Product Change Notification / ASER-27LSS520

CCB 4514 Initial Notice: Qualification of MTAI as an additional assembly site for selected MSCC products available in 48L VQFN (7x7x1mm) package.

CCB 4514
Pre and Post Change Summary
PCN #: ASER-27LSS520

Pre Change

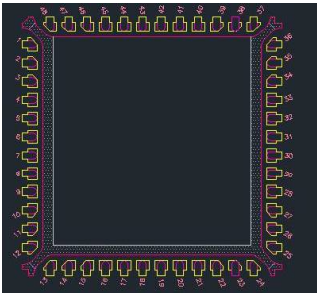
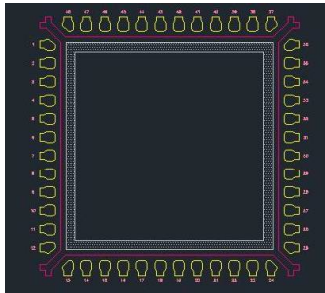
Assembled at ASEM assembly site without lead-lock, using PdCu bond wire, CRM1076DS die attach and CEL-9240HF10AK-G1 mold compound.

Assembled at UNIC assembly site without lead-lock, using CuPdAu bond wire, 8290 die attach and G770HP mold compound.

Assembled at MMT assembly site with lead-lock, using CuPdAu bond wire, 3280 die attach and G700LTD mold compound.

Lead frame Comparison

Post Change

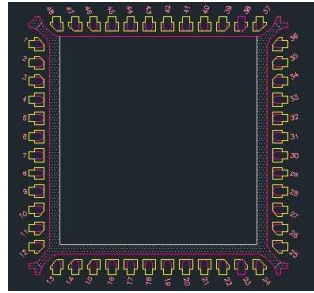
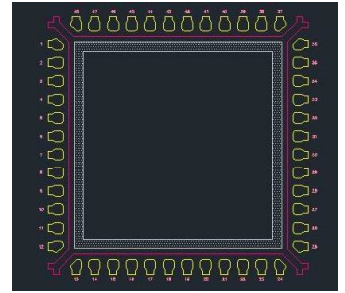
Assembled at MTAI assembly site with lead-lock, using CuPdAu bond wire, 3280 die attach and G700LTD mold compound.
